HEALTH SCIENCES BUILDING RENOVATION

CERRITOS COMMUNITY COLLEGE

Utility Plan

C4.01

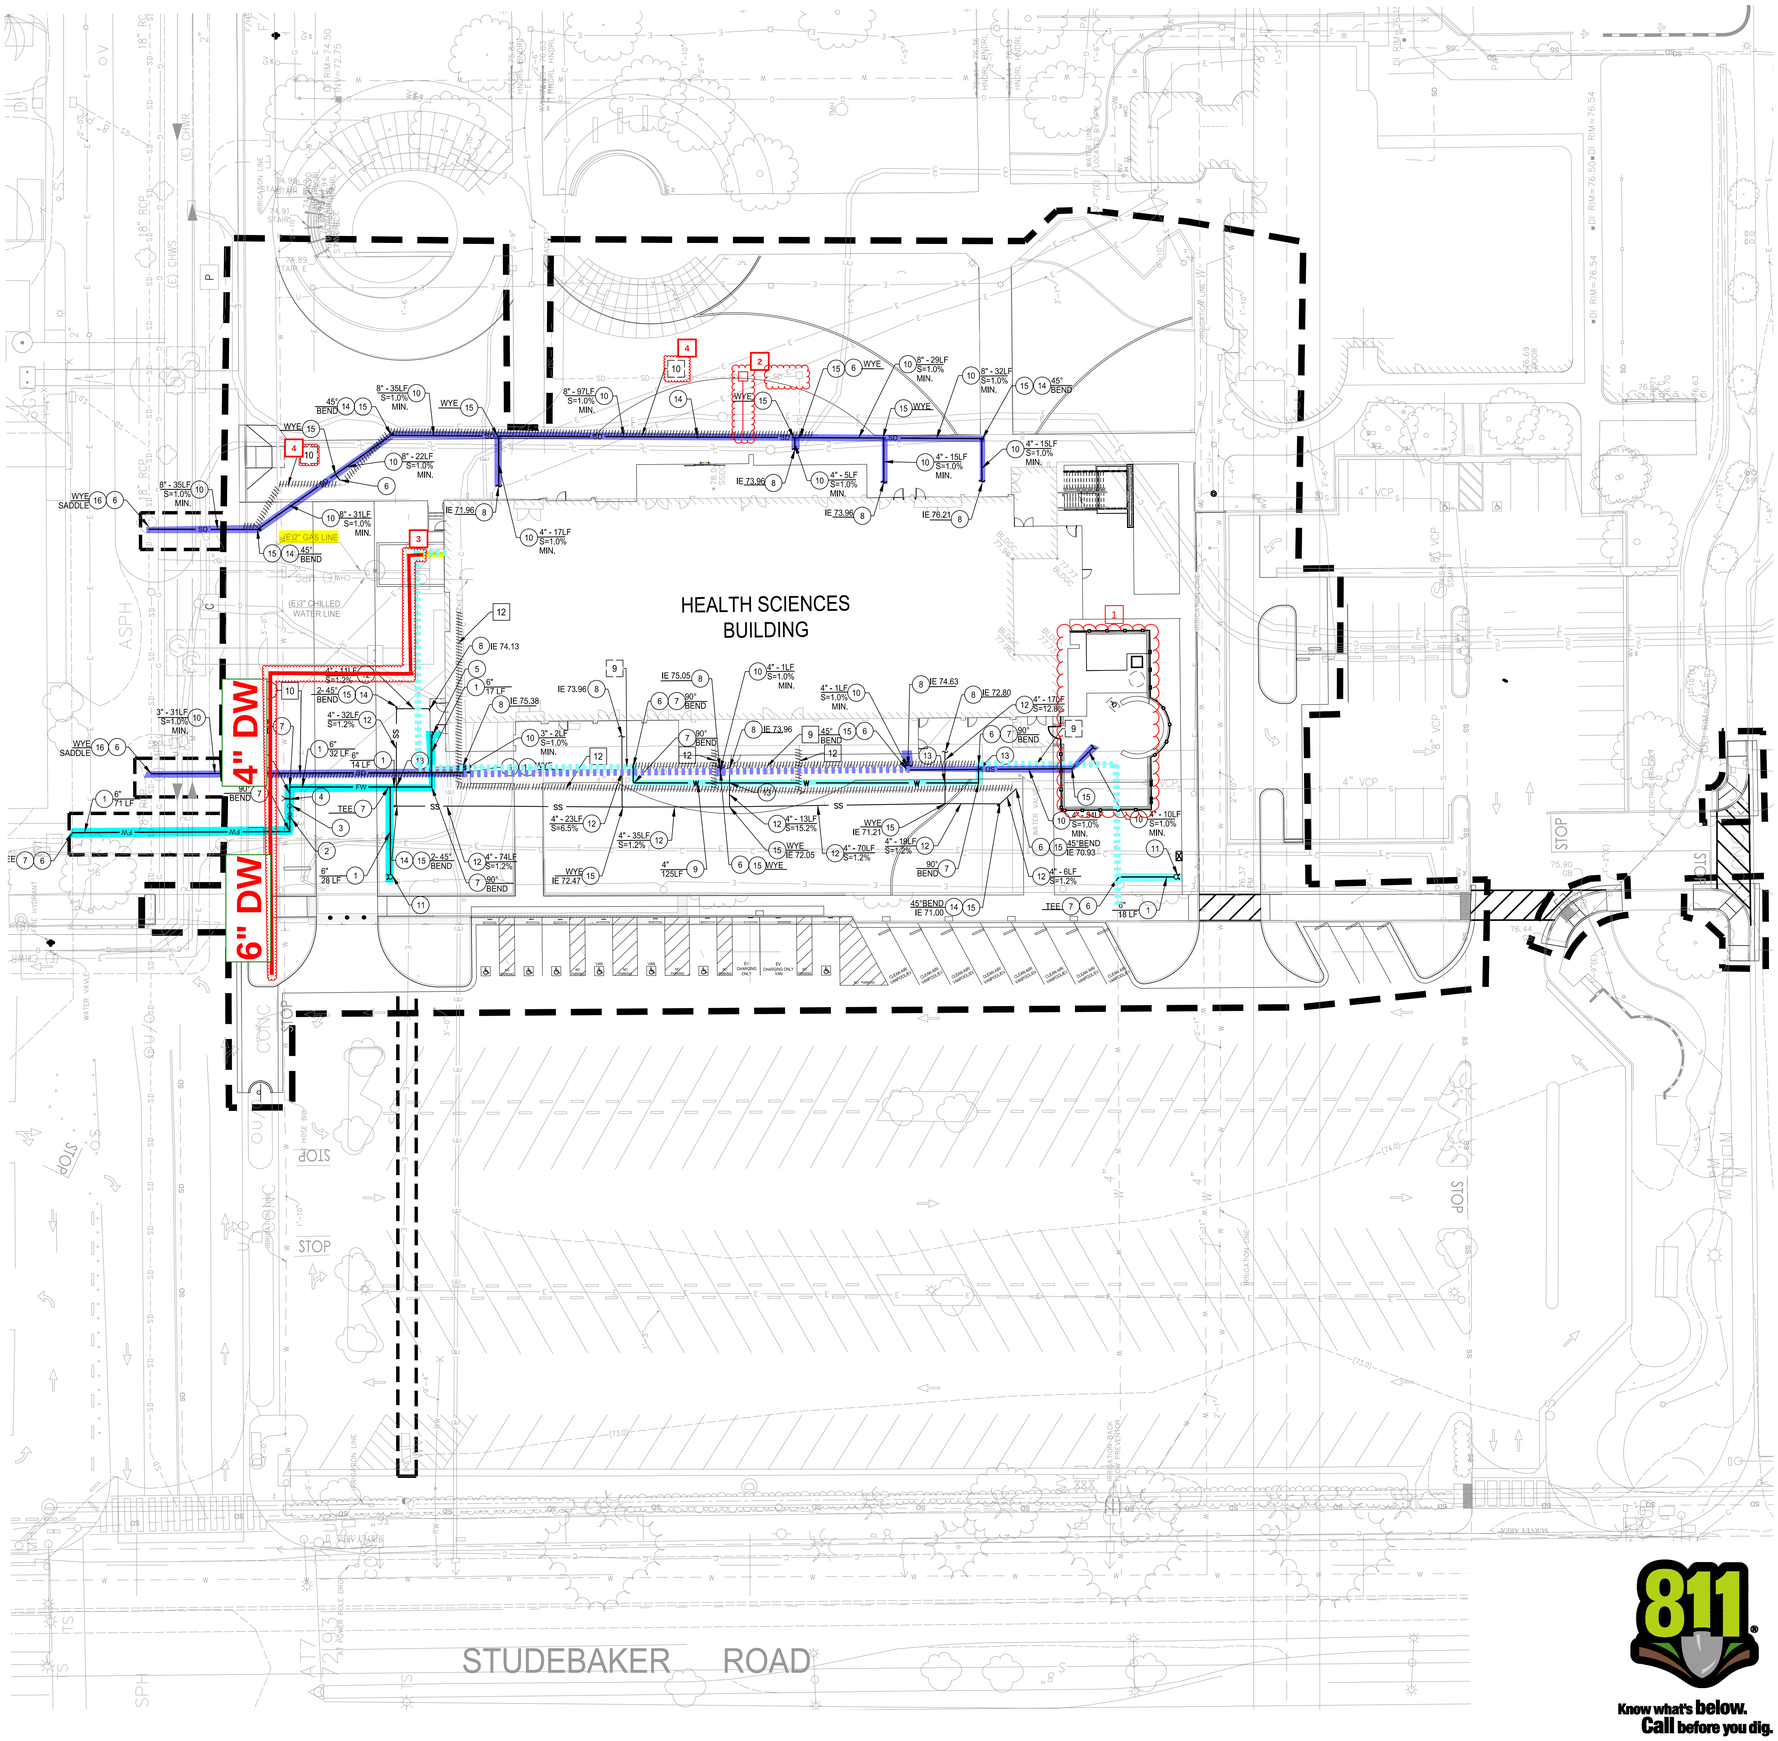
RFI-0090
1 RFI 0090 - 4" Primary Storm drain is to connect to the underdrain in the synthetic turf per L2.1. See suggested locations.

RFI-0289 RFI-0289.1
2 Demo of existing catch basin and provide new catch basin. See RI for more elev info and slopes. New catch basin to match existing.

RFI-0149
3 (N) domestic water isntalled to provide a loop and a point of isolation of the Domestic Water for the (N) Housing Project

RFI-0155
4 Existing storm drain to be removed

SHEET NUMBER
L3.1

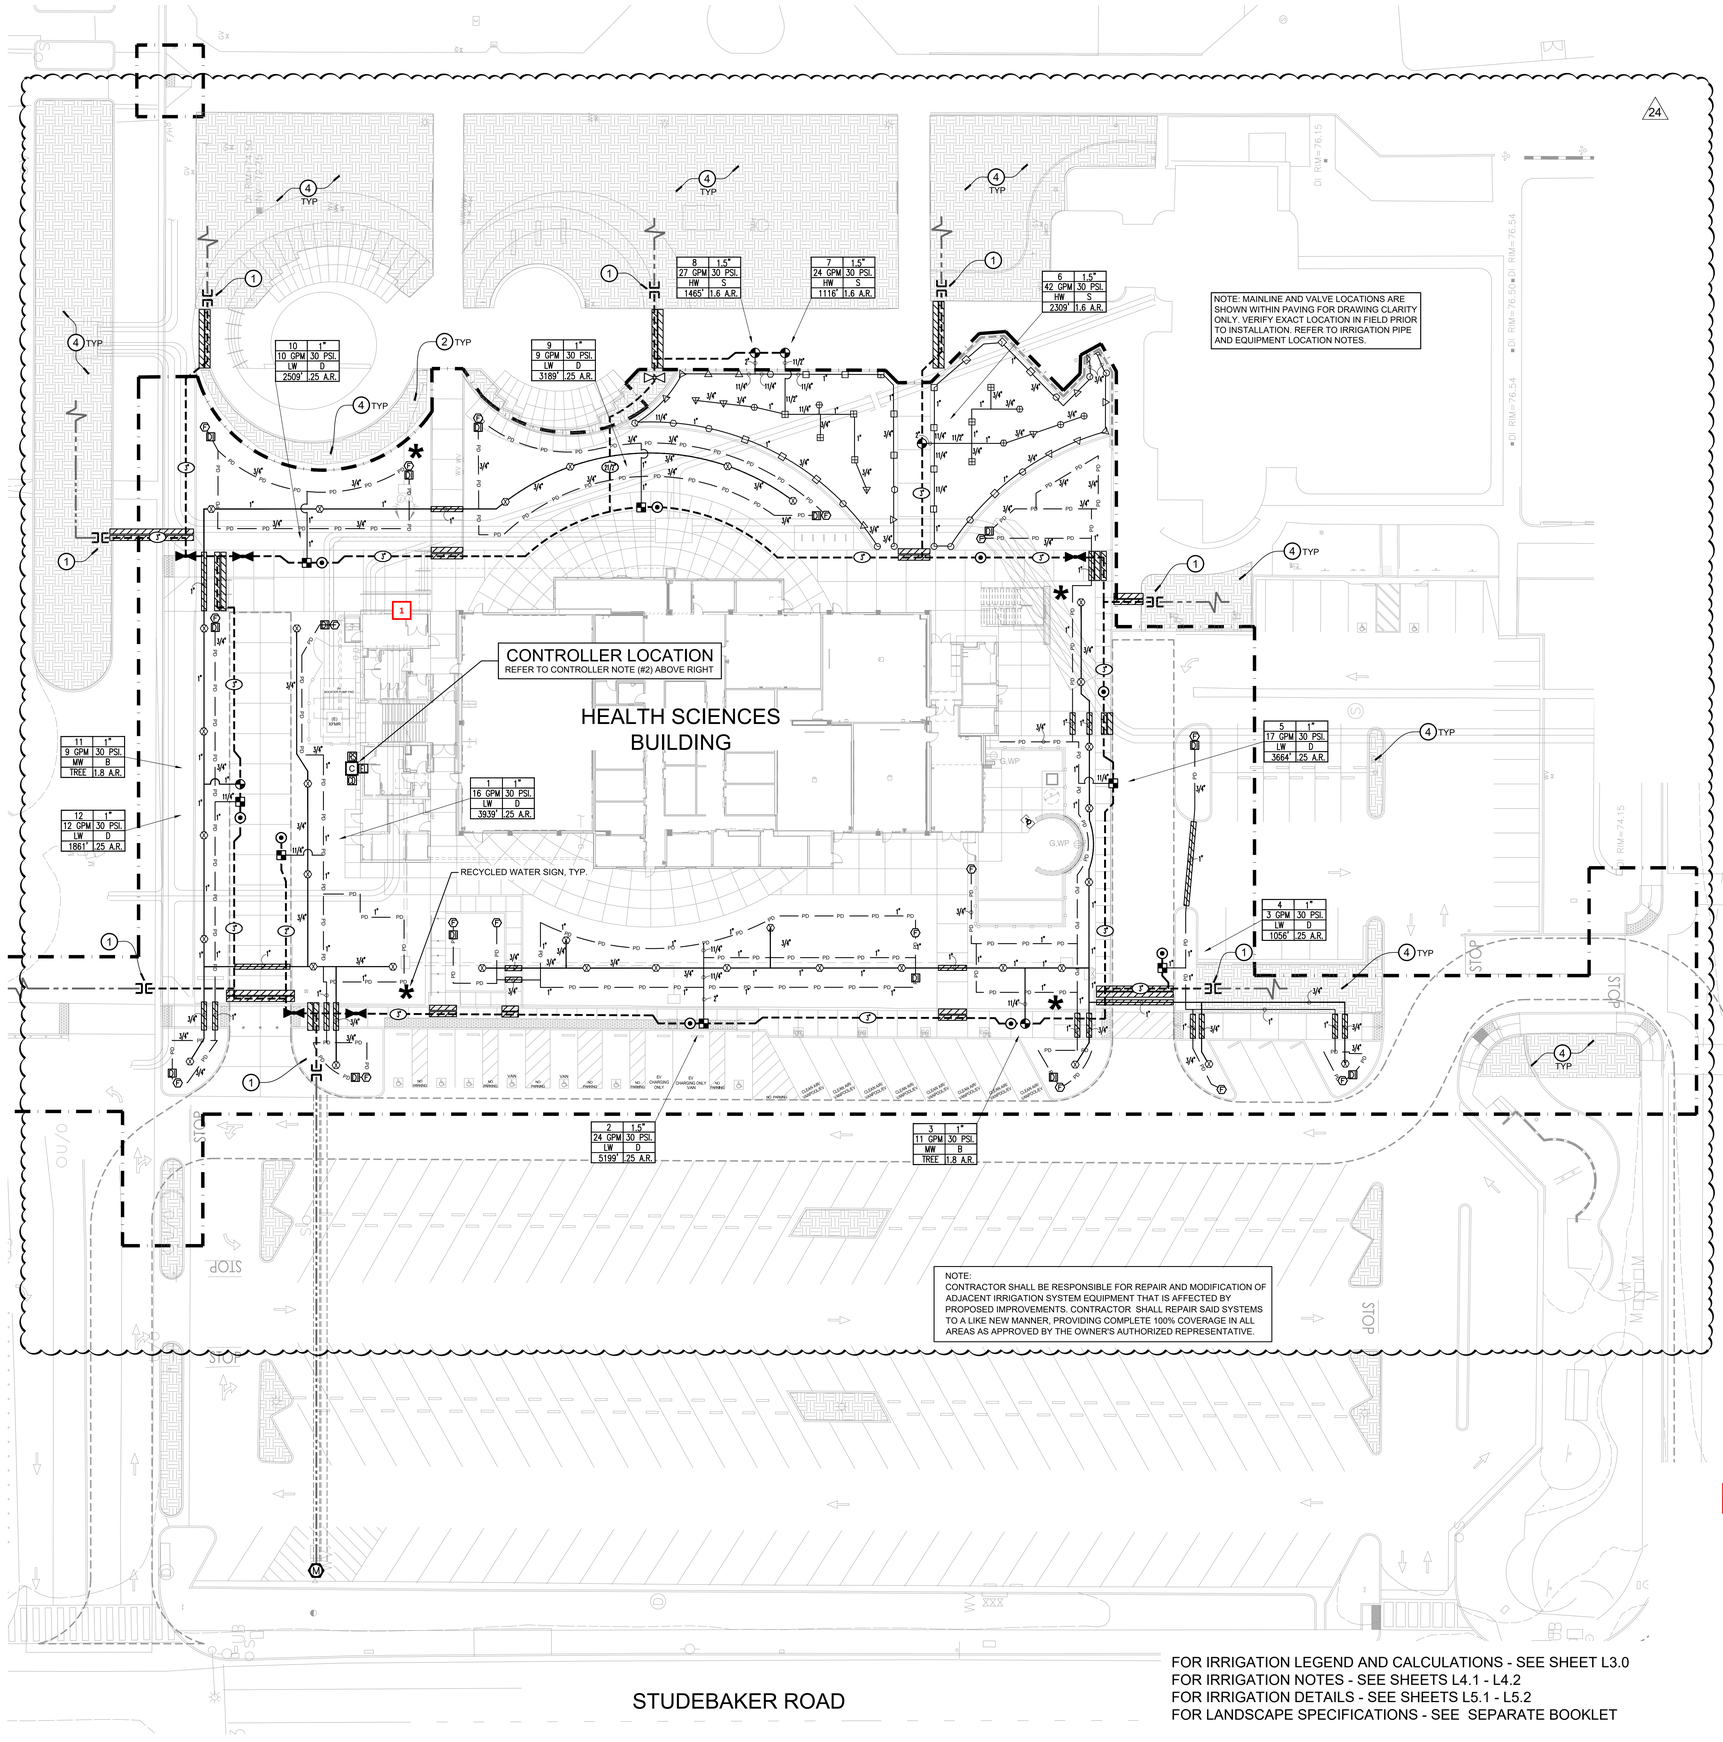
RFI-PB118
1 Transformer location is per DSA approved contract document E1.01 and revised sheet A1.01.

1 POWER SITE PLAN

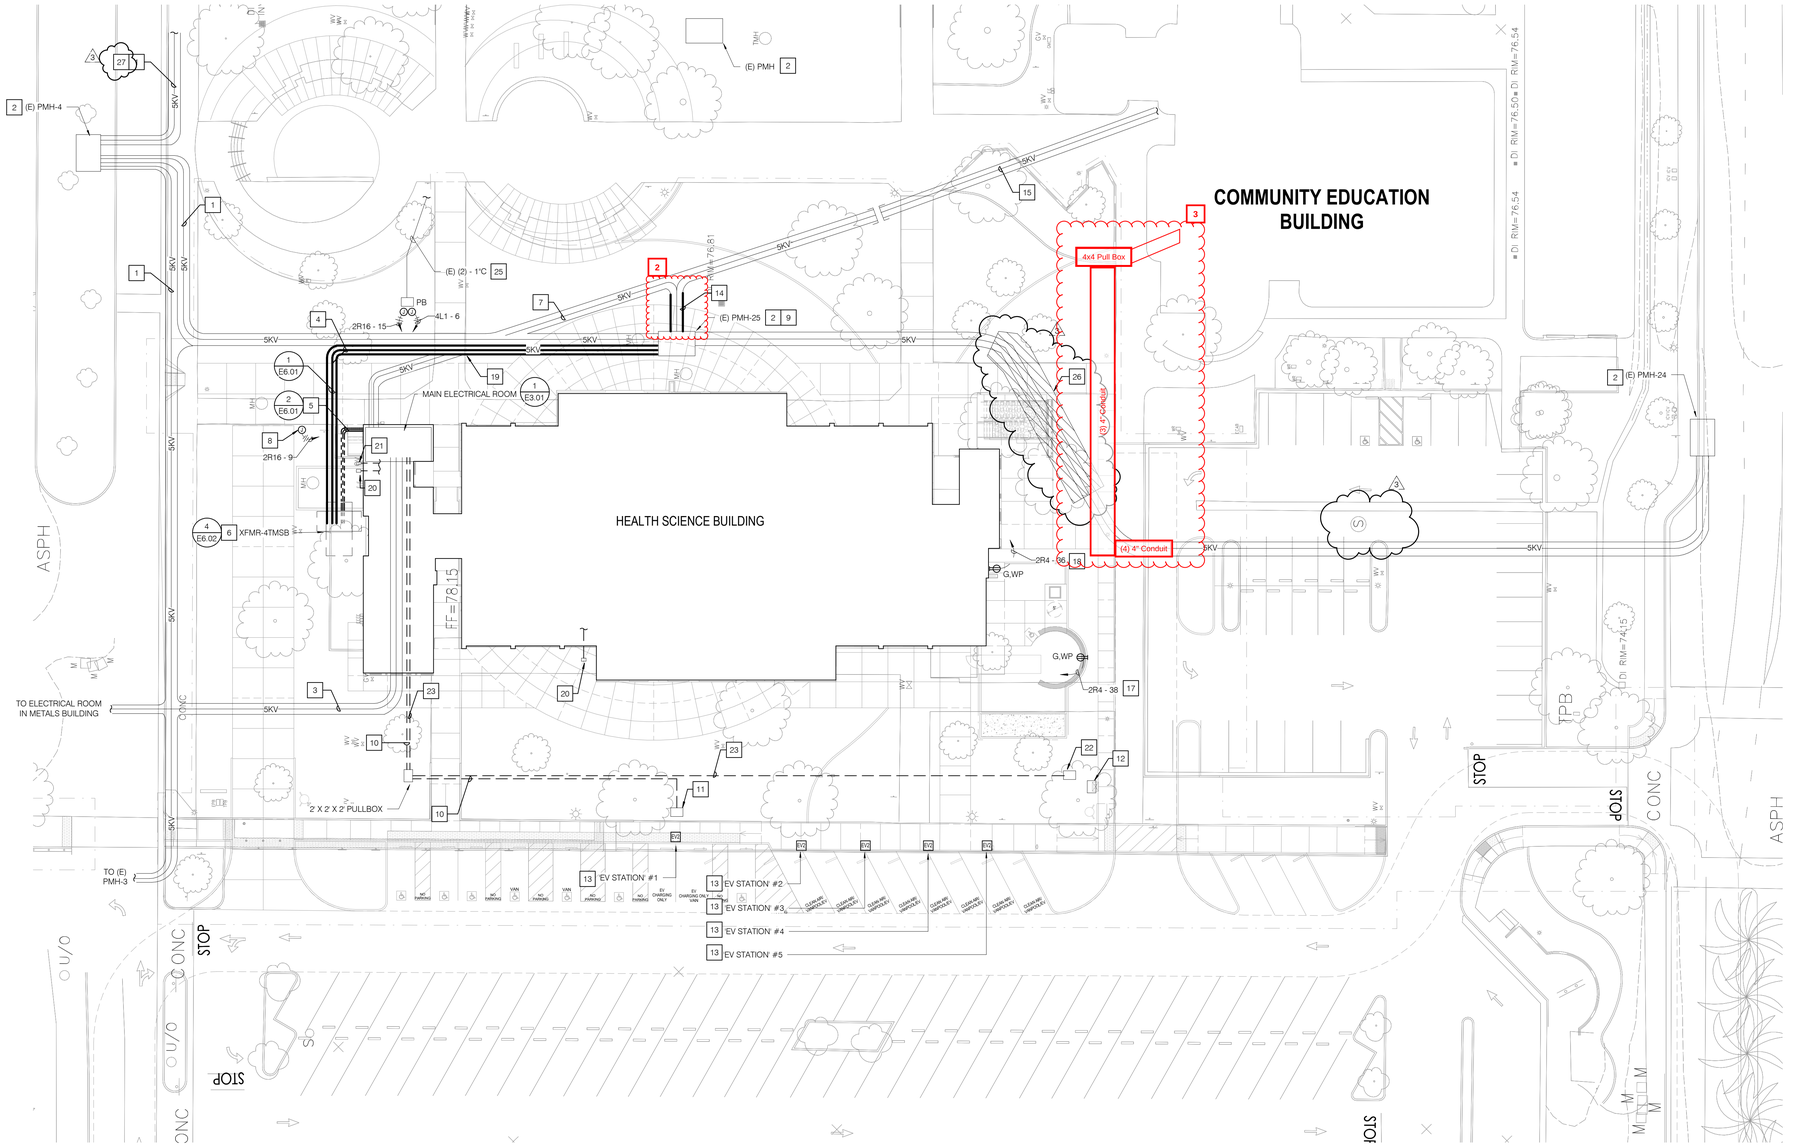
RFI-PB128
1 Devices already relocated.

RFI-0045
2 One 48" radius bend acceptable for medium voltage

RFI-0460
3 Rerouting of Site Medium Low Voltage Feeders

3 26 AFTER NEW MEDIUM VOLTAGE FEEDER PER NOTE 27 IS INSTALLED, CONTRACTOR SHALL DISCONNECT AND REMOVE EXISTING MEDIUM VOLTAGE FEEDER BETWEEN PMH-25 AND PMH-24 TO ALLOW MINIMAL DOWNTIME FOR DOWNSTREAM BUILDINGS. DEMO EXISTING CONDUIT IN CONFLICT WITH NEW STAIR FOOTING TO 5 FEET BEYOND OVER EX. SEE MEDIUM VOLTAGE SINGLE LINE ON SHEET E5.01 FOR ADDITIONAL INFORMATION.

1 TECHNOLOGY SITE PLAN
SCALE: 1/16" = 1'-0"

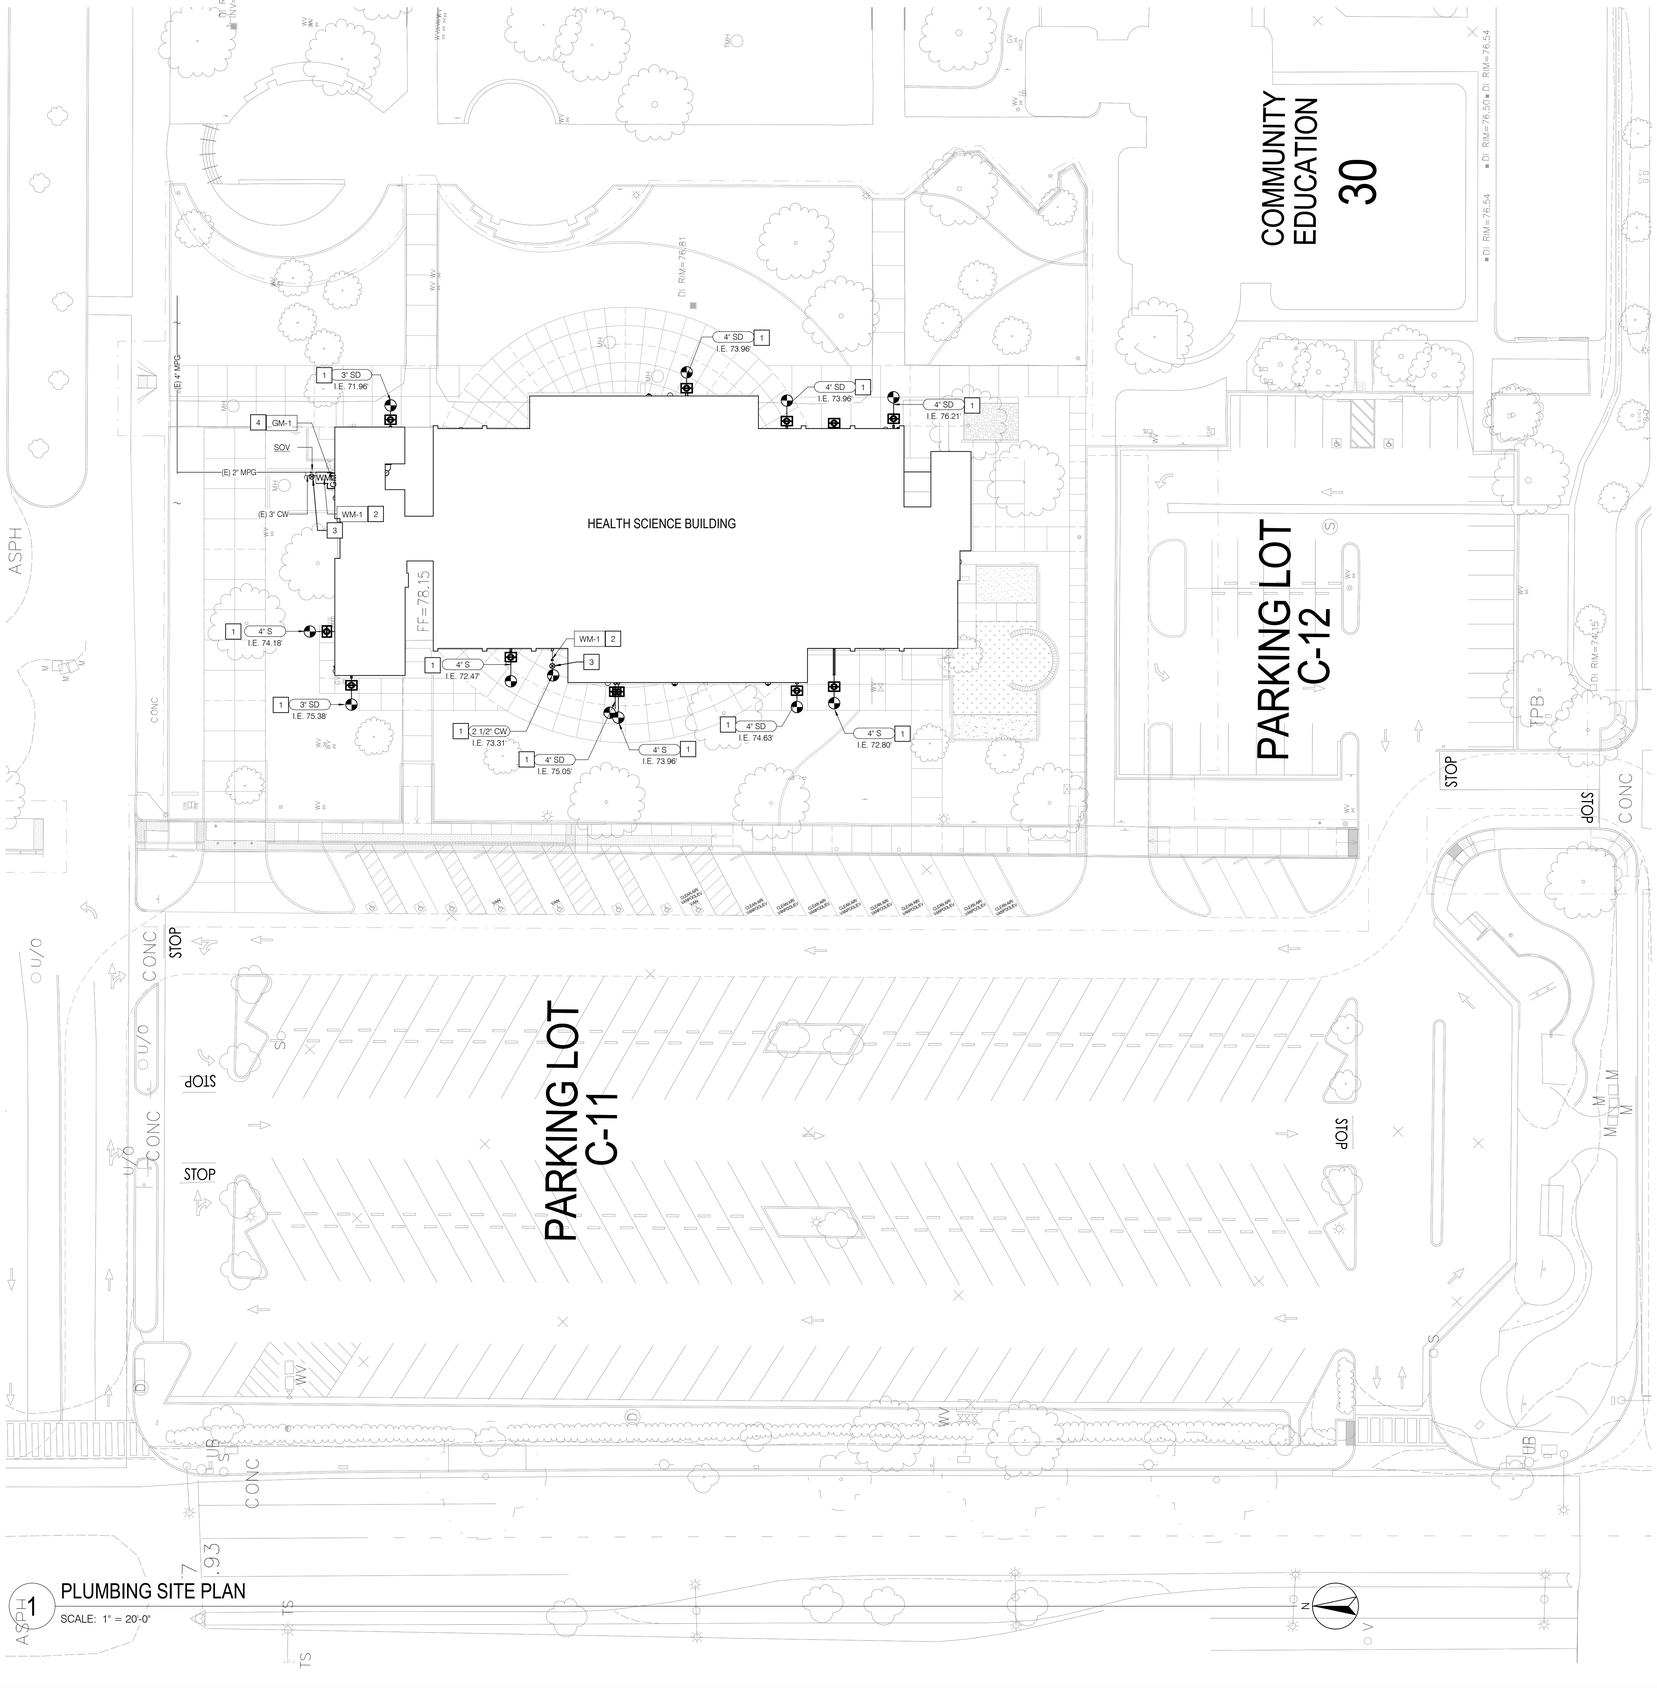
RFI-PB387
1 RFI confirms that relocation of emergency blue phone tower is already relocated.
